Re: Dominion's Surry-Skiffes Creek 500 kV Line: Response to National Trust for Historic Preservation's October 28, 2016, Presentation Regarding Load Flow Analyses and Project Alternatives

**Surry – Skiffes Creek – Whealton**  
*Modeling Review of NTHP/Tabors  
Alternatives*

**Tabors Alt. A**  
**(Reconductor**  
**and**  
**Reconfigure)**  
**Summer 2016**

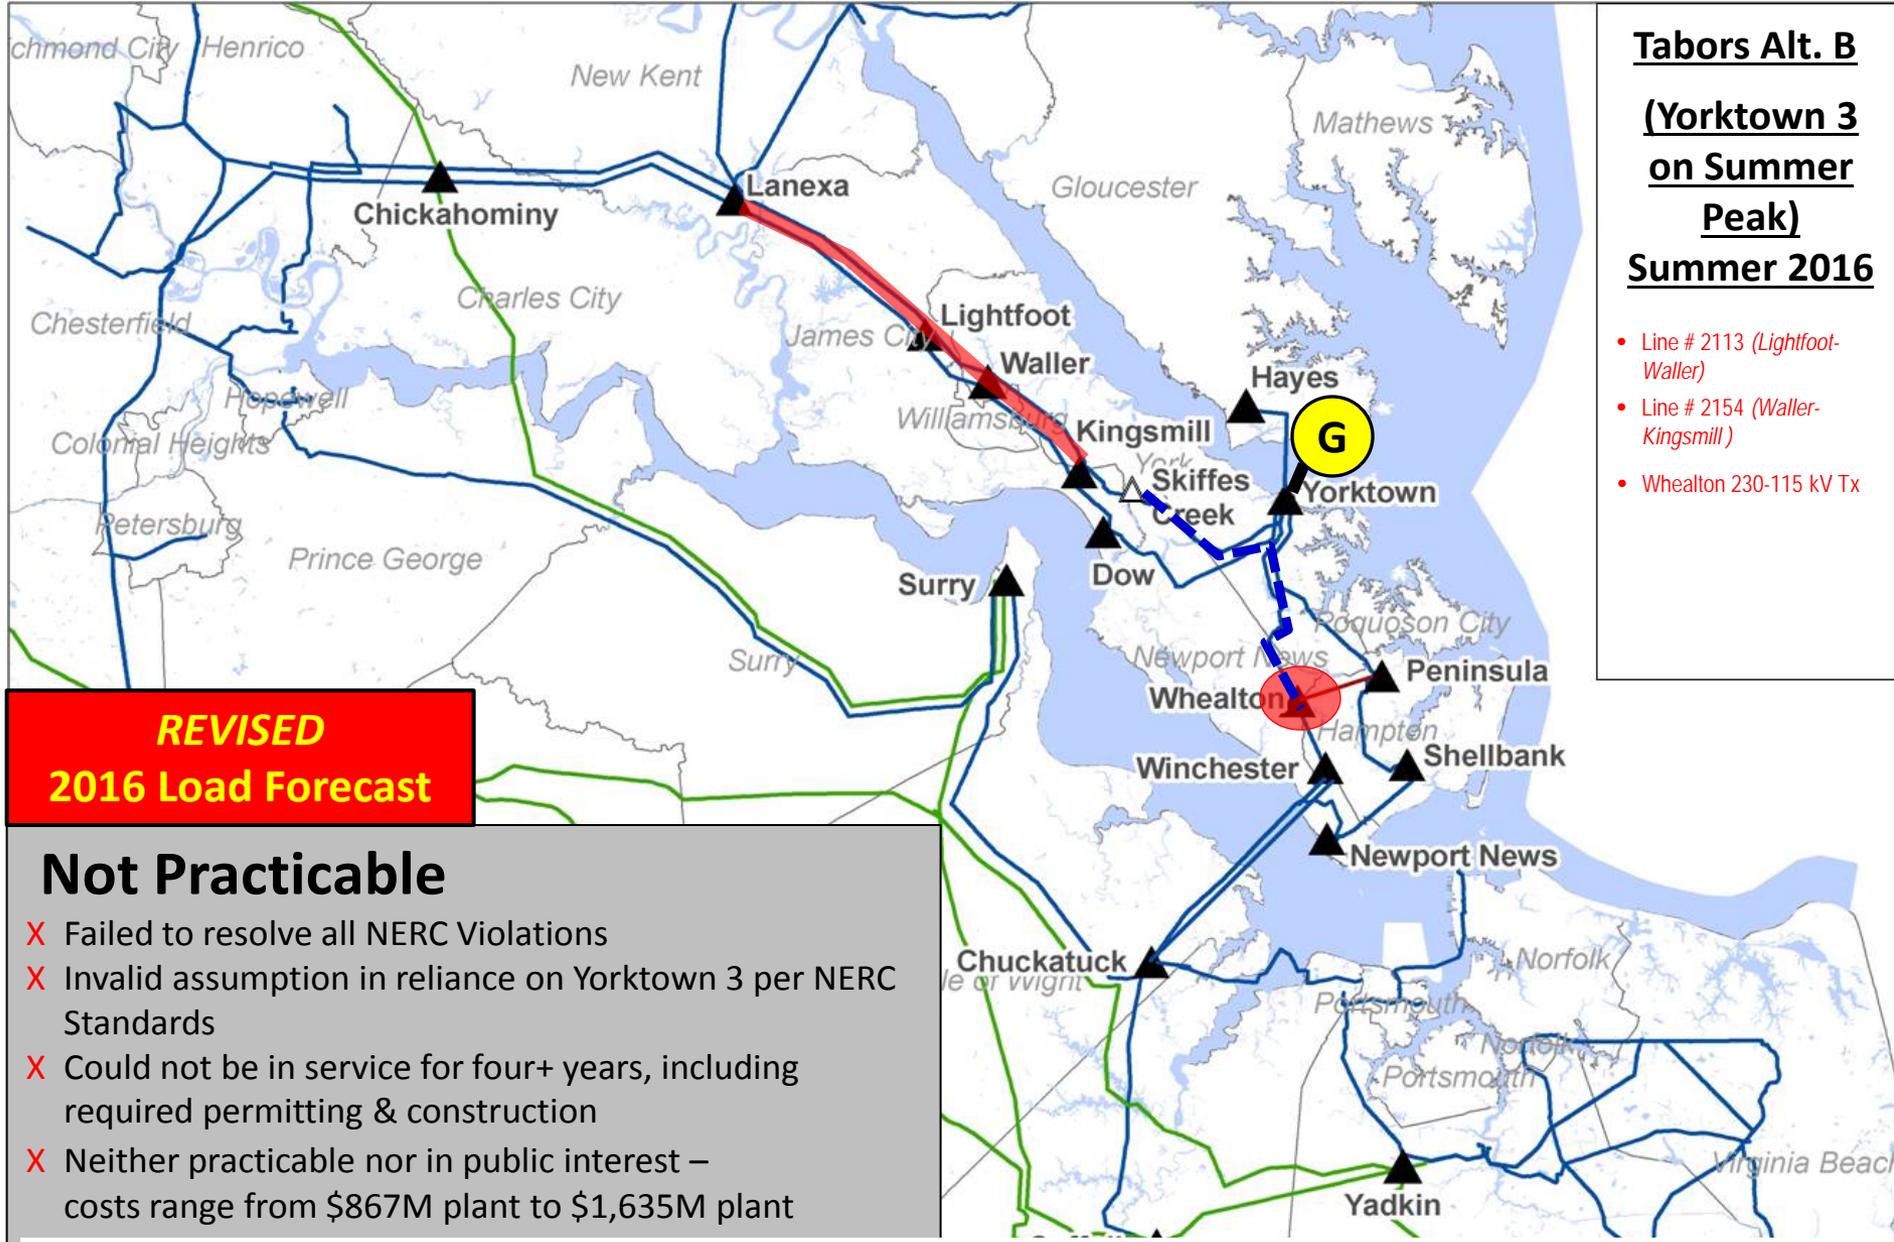
- Line # 2113 (Lightfoot-Waller)
- Line # 2154 (Waller-Skiffes Creek)
- Line # 34 (Skiffes-Ft Eustis)
- Line # 58 (Lanexa-Skiffes)
- Whealton 230-115 kV Tx

- ✗ Failed to resolve all NERC Violations
- ✗ Could not be in service for seven+ years, including required permitting & construction
- ✗ Neither practicable nor in public interest – cost over \$571M

**Tabors Alt. B**  
**(Yorktown 3**  
**on Summer**  
**Peak)**  
**Summer 2016**

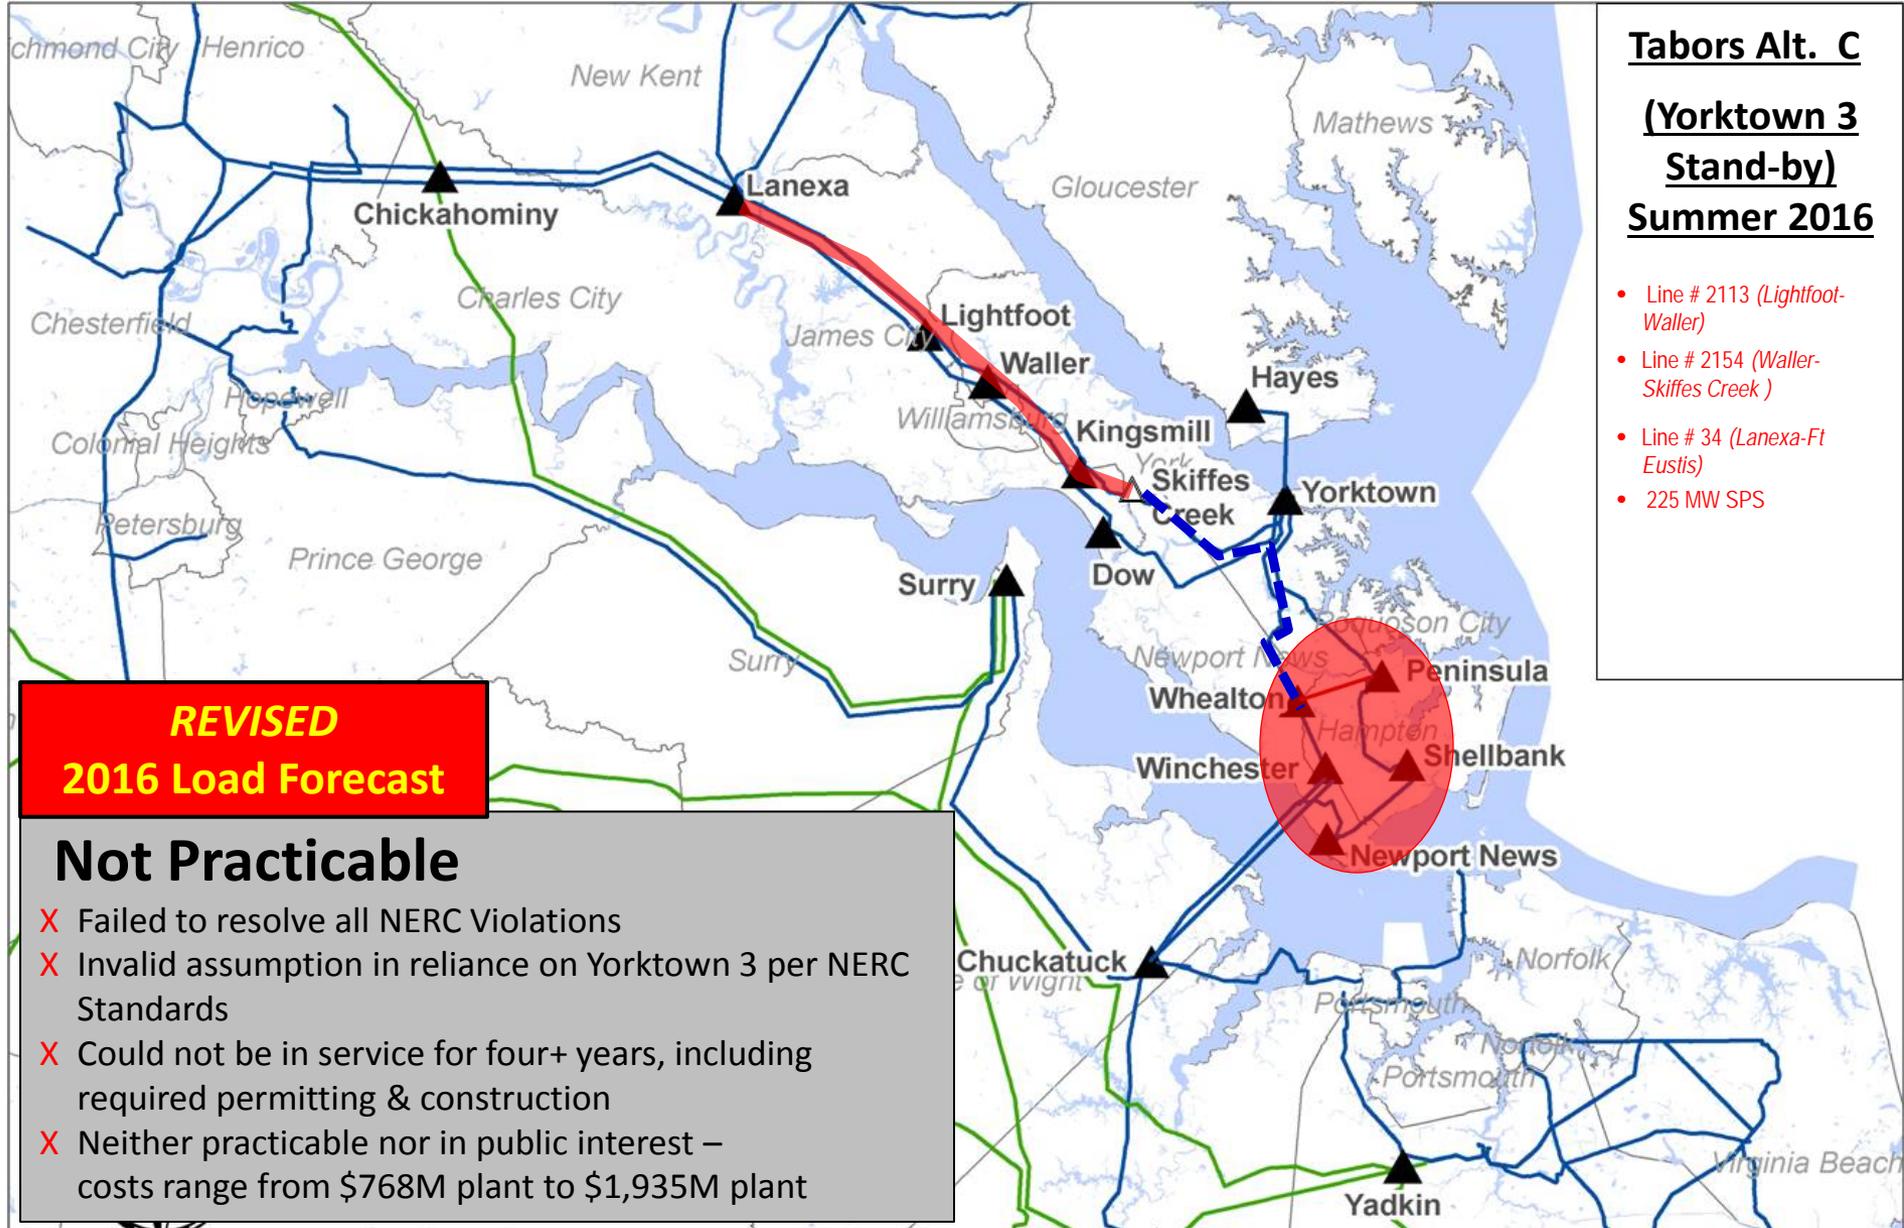
- Line # 2113 (Lightfoot-Waller)
- Line # 2154 (Waller-Kingsmill)
- Whealton 230-115 kV Tx

- X Failed to resolve all NERC Violations
- X Invalid assumption in reliance on Yorktown 3 per NERC Standards
- X Could not be in service for four+ years, including required permitting & construction
- X Neither practicable nor in public interest – costs range from \$867M plant to \$1,635M plant

**Tabor Alt. D**  
**(Bypassing**  
**Critical ROWs)**  
**Summer 2016**

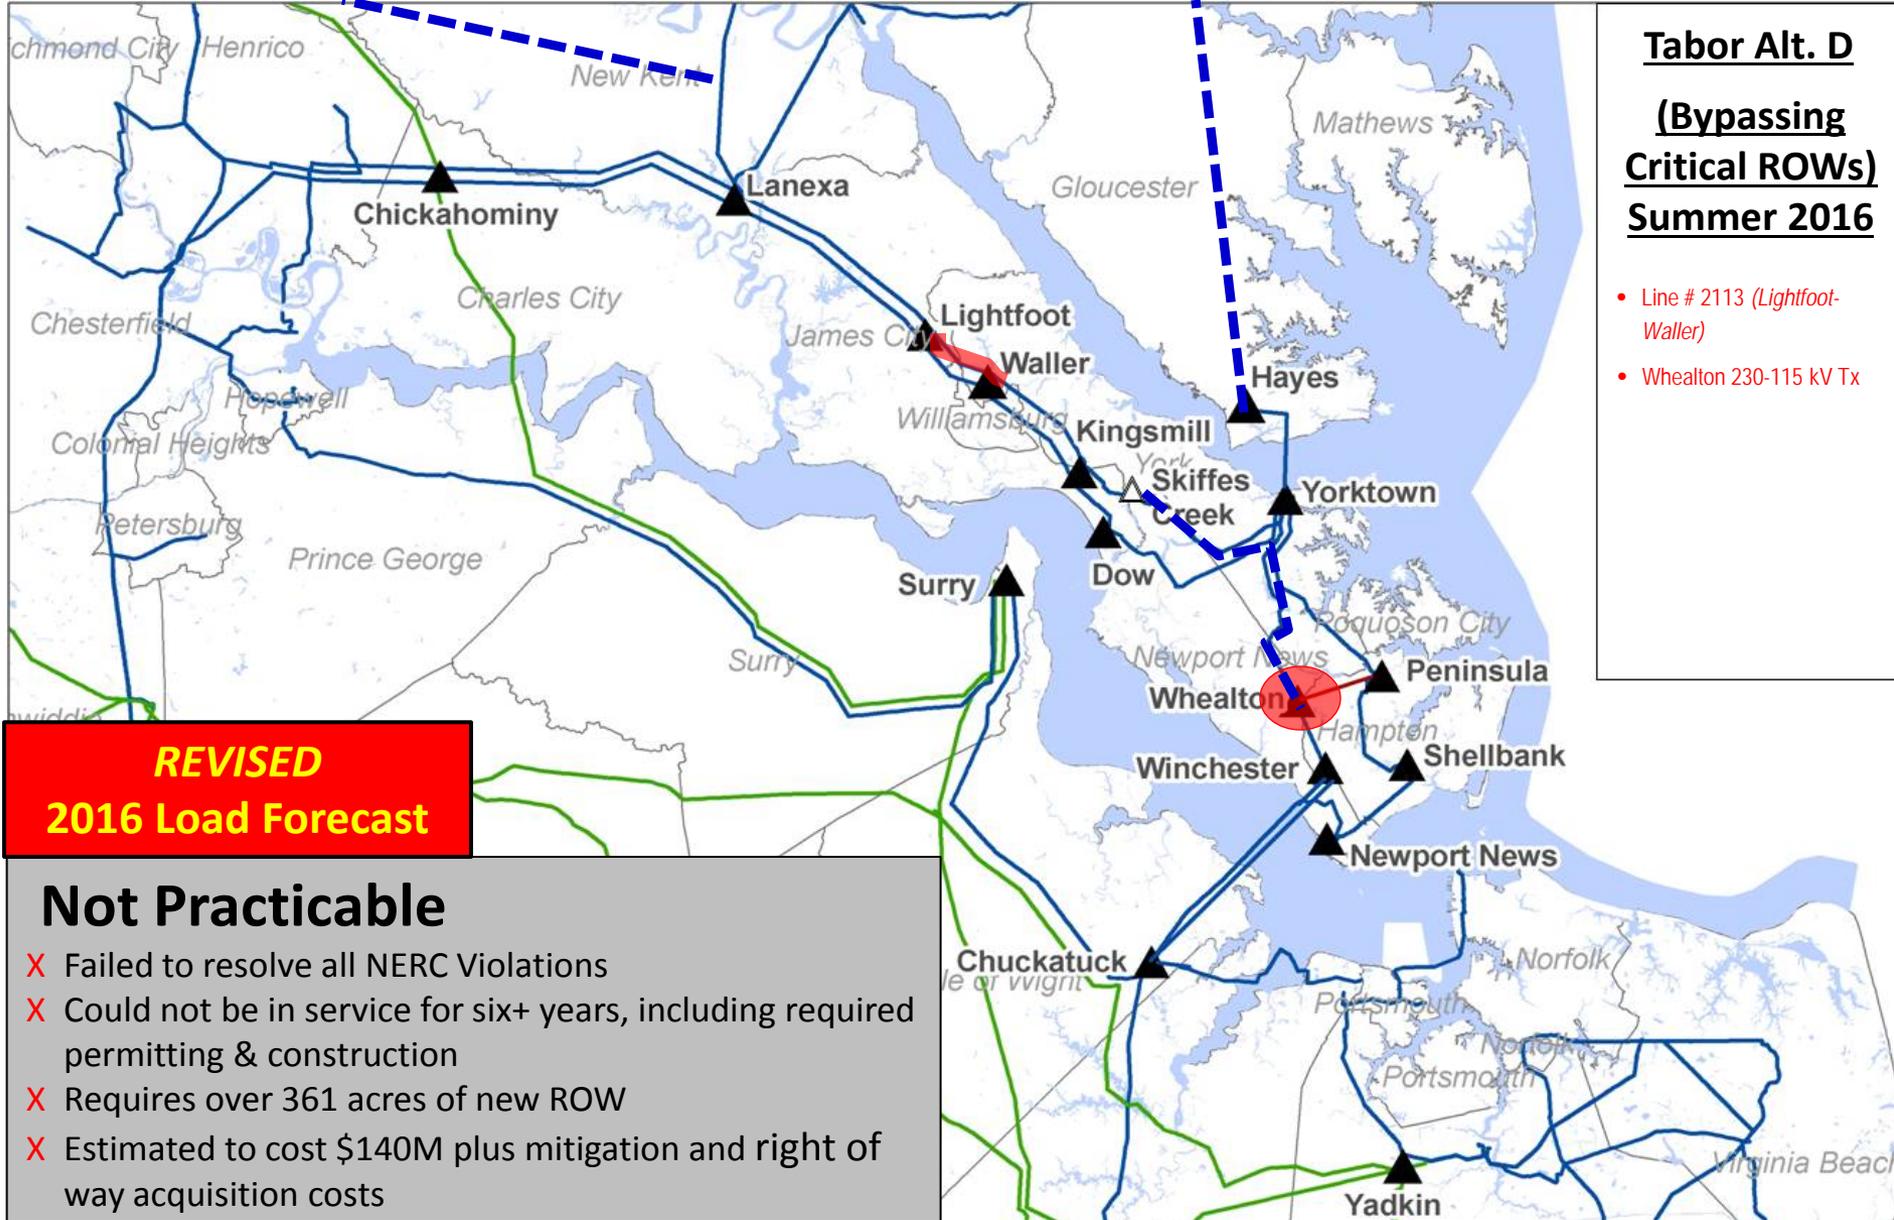
- Line # 2113 (Lightfoot-Waller)
- Whealton 230-115 kV Tx

- X Failed to resolve all NERC Violations
- X Could not be in service for six+ years, including required permitting & construction
- X Requires over 361 acres of new ROW
- X Estimated to cost \$140M plus mitigation and right of way acquisition costs
